ALTERNATIVE METHODS OR CONSTRUCTION MATERIALS REQUEST

Engineering Design Standards

E21-0570

HEET NO. A0.5

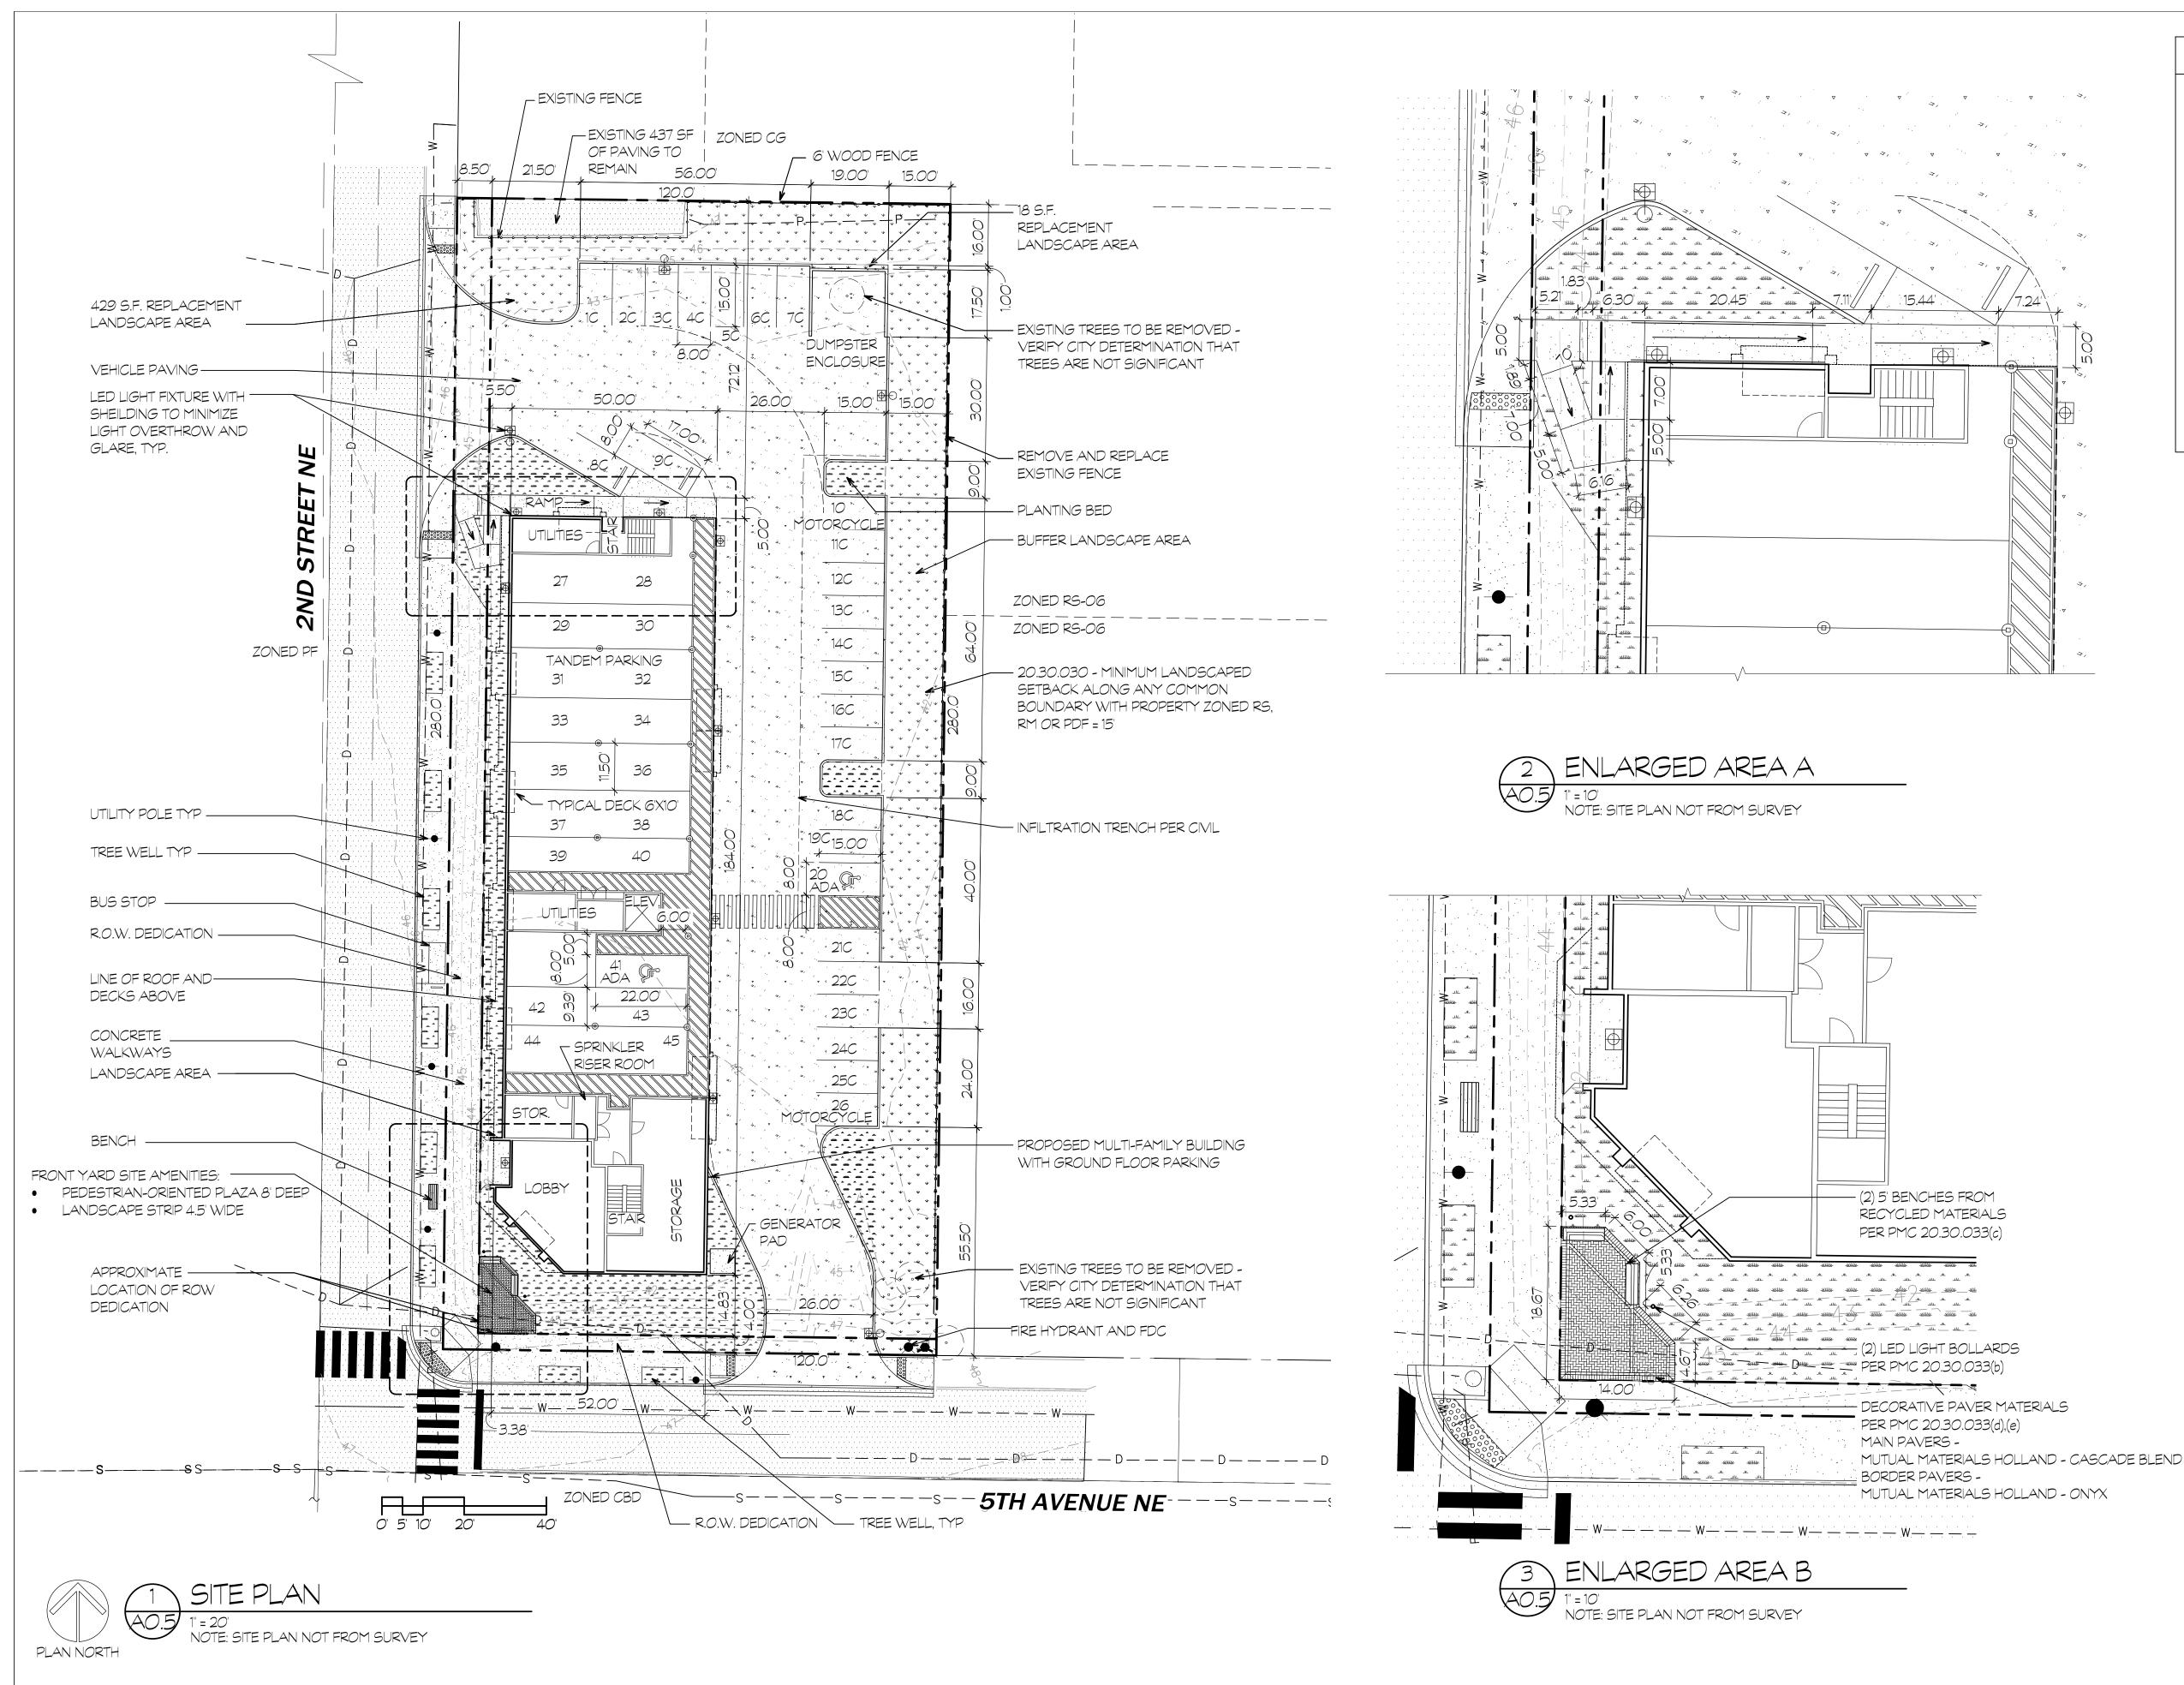
referenced within items 1-7.
1. Describe the proposed modification (from what requirements are you seeking relief?).
Section 101.10.1 of the Puyallup Public Works Engineering & Construction Standards restricts driveway spacing on arterials to no
closer than 300 feet to an intersection or another driveway. The project proposes to locate the driveway to 2nd St NE, a Major Arterial, at reduced spacing. The proposed driveway would be
spaced approximately 223 feet from the intersection and 65' from the adjacent driveway north of the project.

STAFF	APPROVED	DENIED	DATE		
RECOMMENDATIONS					
Development Engineering	Intelini		1/24/2022		
Conditions:					
No objections due to lot size and exis	sting constraintssee additional R	Reviewer comments below.			
Planning Department	N/A				
Conditions:					
Traffic Engineering	X		1/21/2022		
Conditions: During civil review, the applicant will provide an entering sight distance analysis to ensure there are no sight obstructions. Driveway must provide pavement markings & signage indicating right-in/right-out operation at 2nd St NE					
Public Works - Streets	N/A				
Conditions:					
Public Works - Water	per CHale email dated 11/16/21		11/16/2021		
Conditions:					
The Water Division has no comments	s on this AMR, we defer to the Cit	y Engineer			
Public Works - Collections	per JWikander email dated 11/16/21		11/16/2021		
Conditions: If approved, please make sure all storm and/or sewer structures will be updated as needed should they conflict with the new entrance(s). Otherwise, no comments.
